CITY OF PATASKALA PLANNING AND ZONING COMMISSION

STAFF REPORT

Final Plan Application FP-24-001

Hazelton Crossing Phase 1 – Final Plan Review

Ex.C - Sub Area 'D' Phase 1 Illustrative Plan

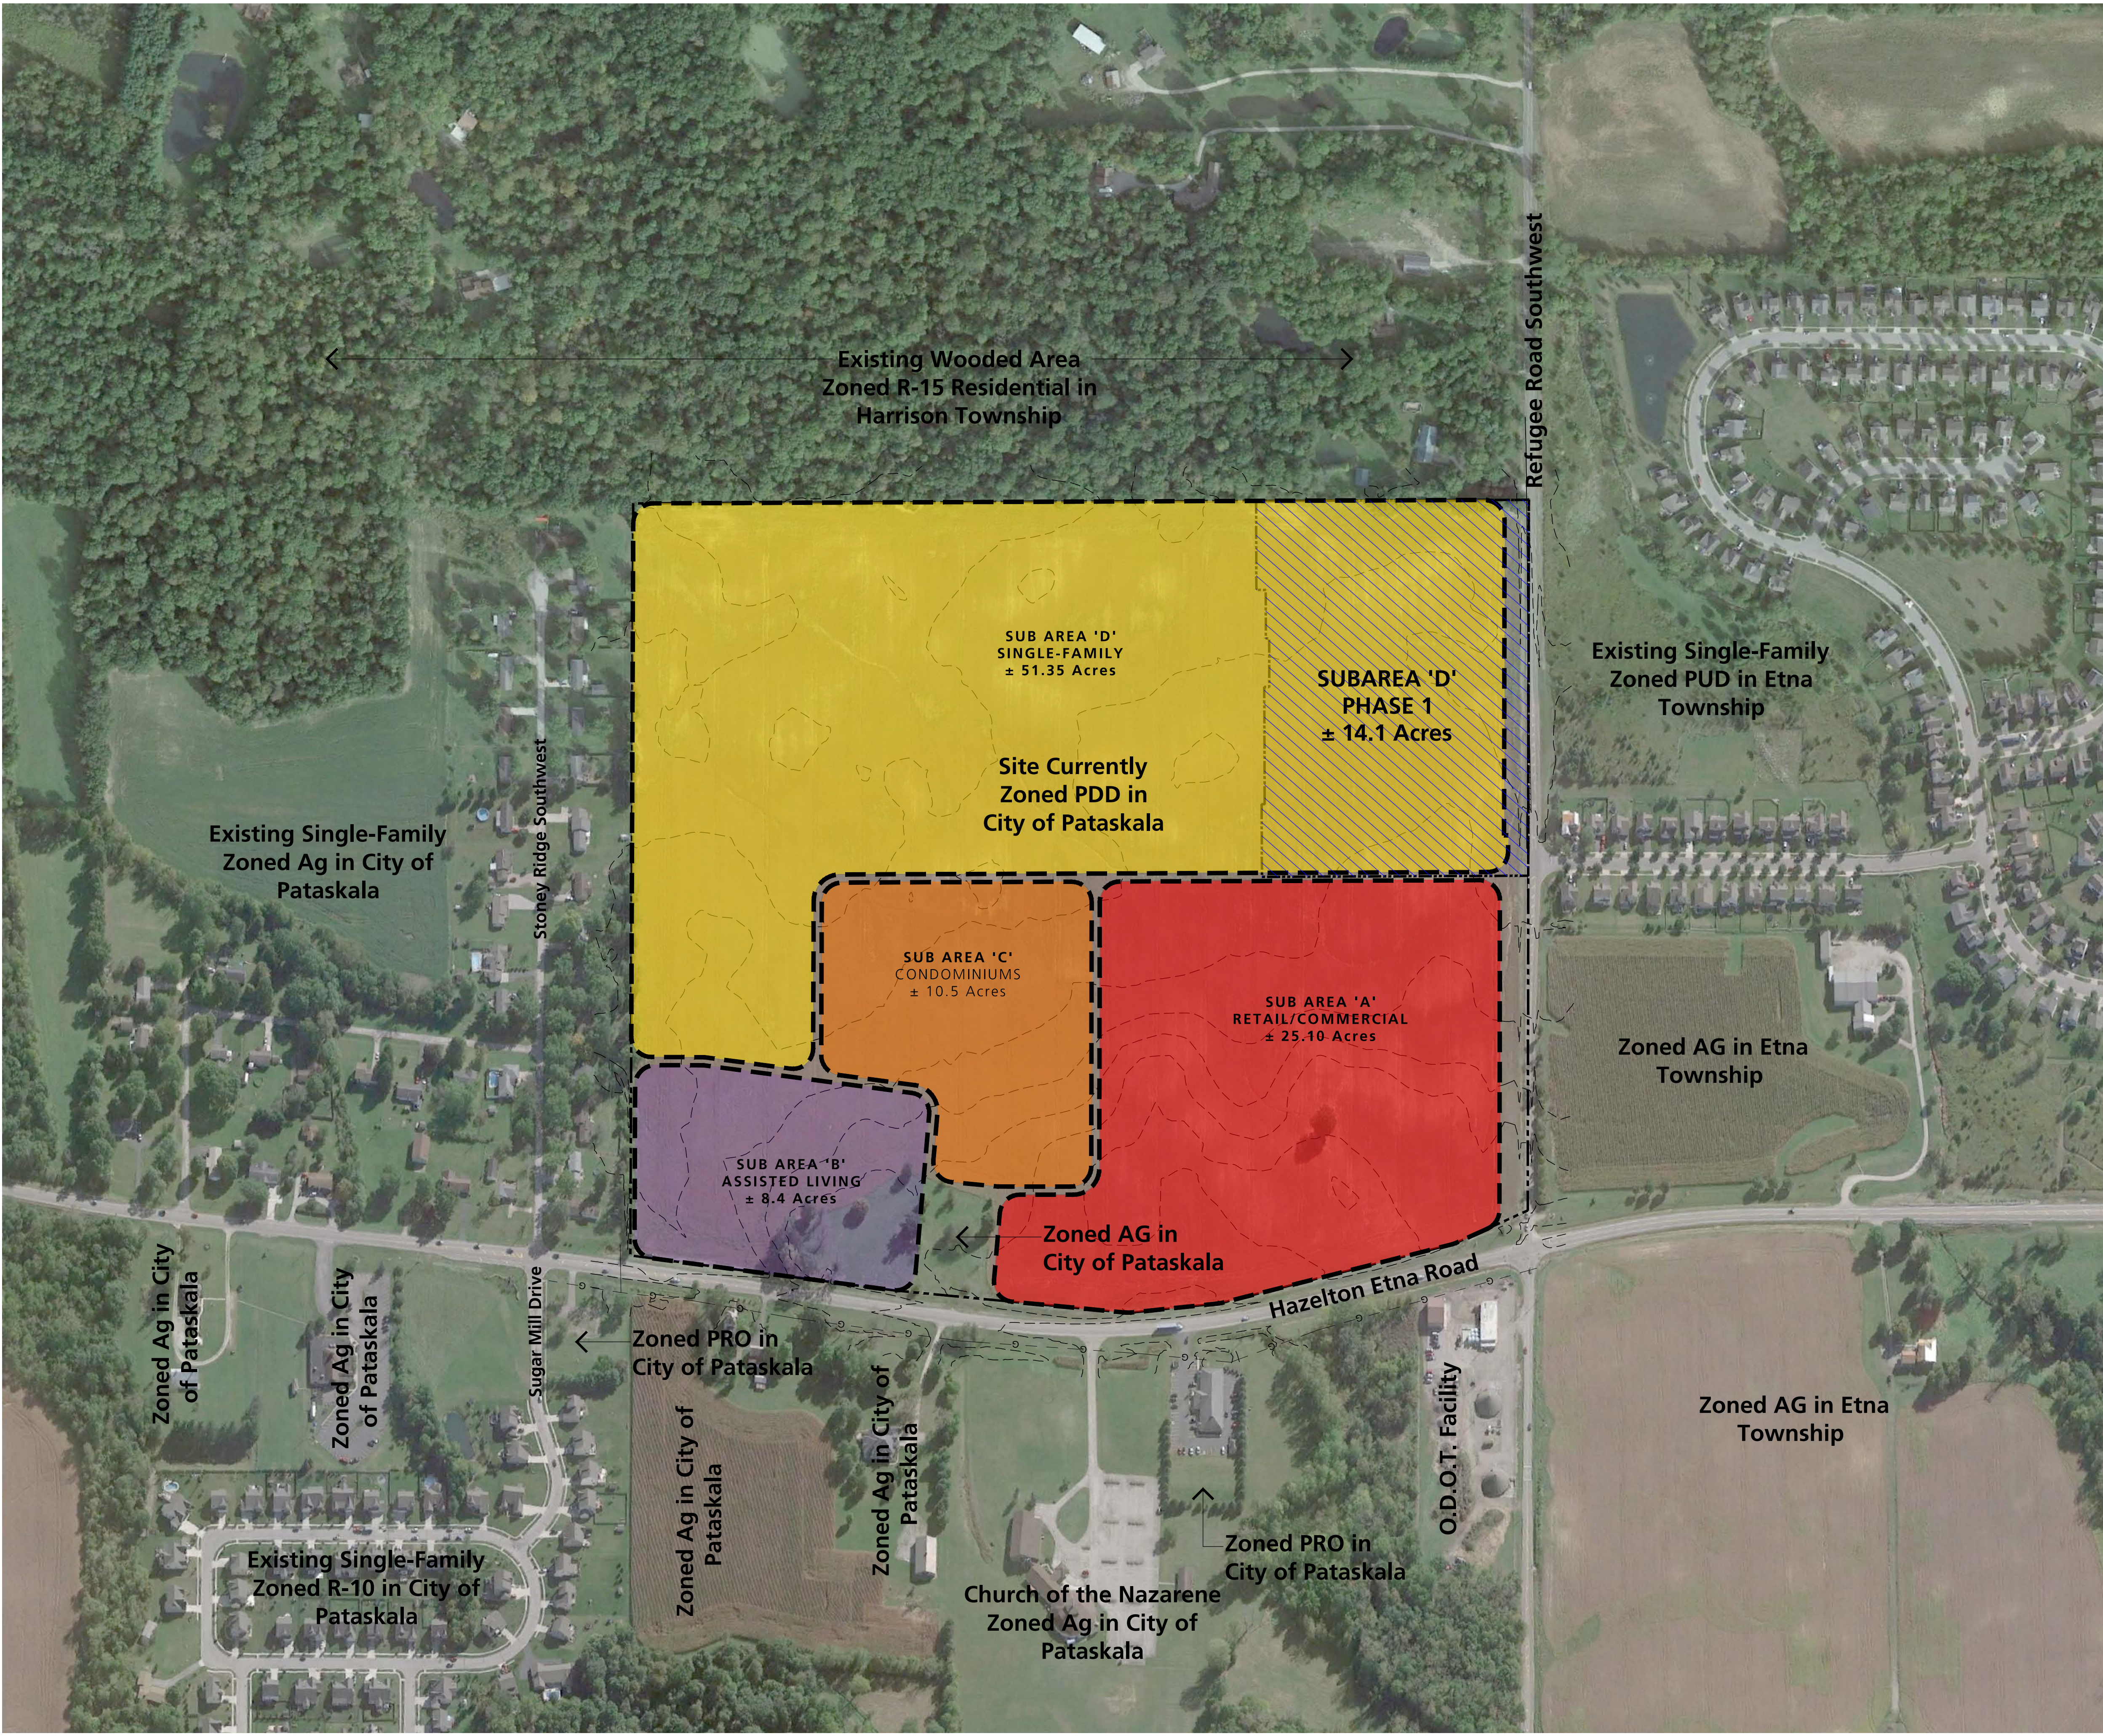
1. Lot 41 appears too close to the adjacent curve in the street to the west. At a minimum, restrict the driveway for this lot to be to the east side of the lot.
2. Suggest ADA ramps be installed at all corners of the proposed intersections.
3. ROW needs dedicated per an approved set of Refugee Road turn lane improvements. The plans need to be reviewed by the City and the County Engineer. Plans should consider a pedestrian pathway along the frontage of the development.
4. Verify the adequacy of the storm sewer outfall for the proposed ponds. Explain how far downstream the capacity of the roadside ditch was analyzed.

- Comments relating to City Engineer's above:
 - #3 – assumed ROW dedication will be addressed with Refugee Road Turn Lane Plans (awaiting submittal), pathway is shown on plans.
 - #4 – Addressed with approved Construction Plans.
 - Comments #1 and #2 are valid.

Ex.C1 - Sub Area 'D' Ph. 1 Final Development Plan

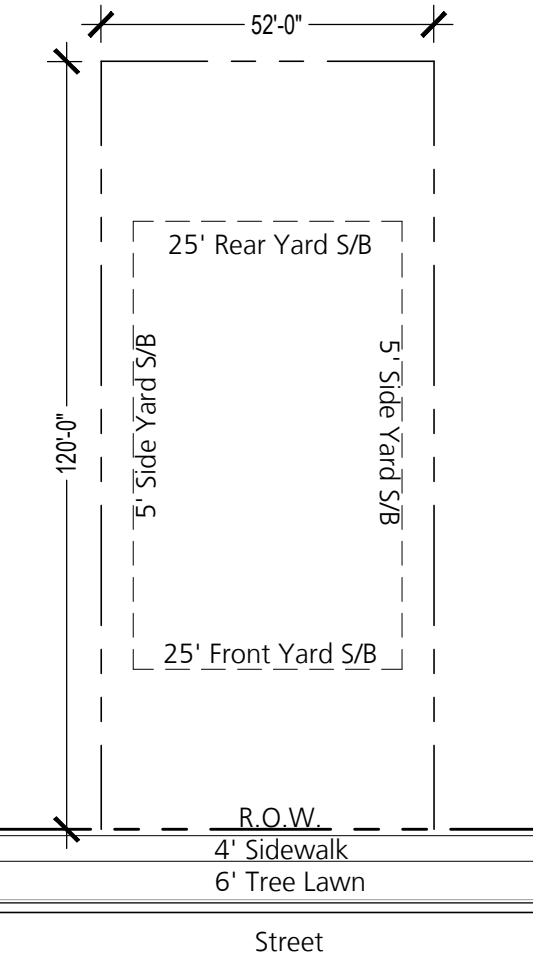
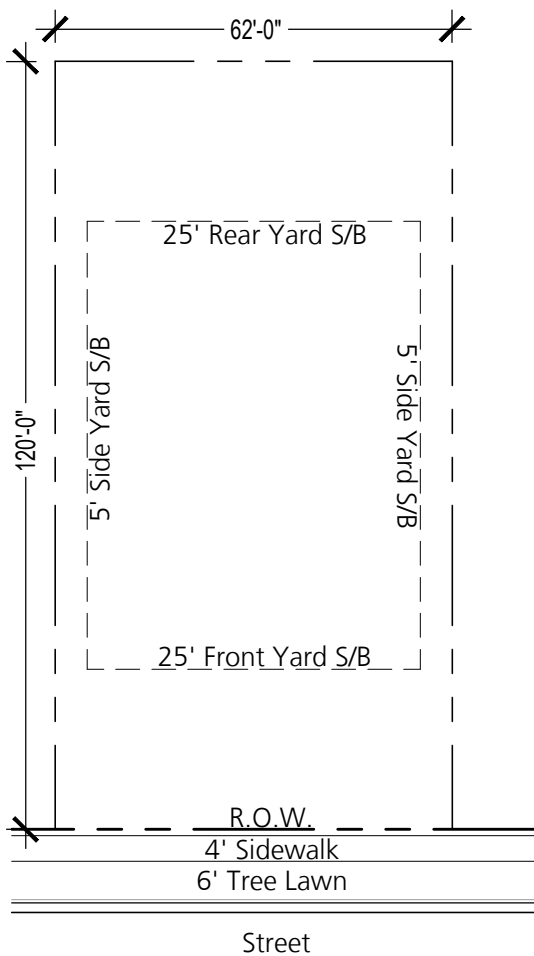
- 1113.23(j): include typical cross sections of proposed streets widths.
- 1113.23(l): show building setback lines on lots.
- 1113.23(p): indicate widths of sidewalks/paths.
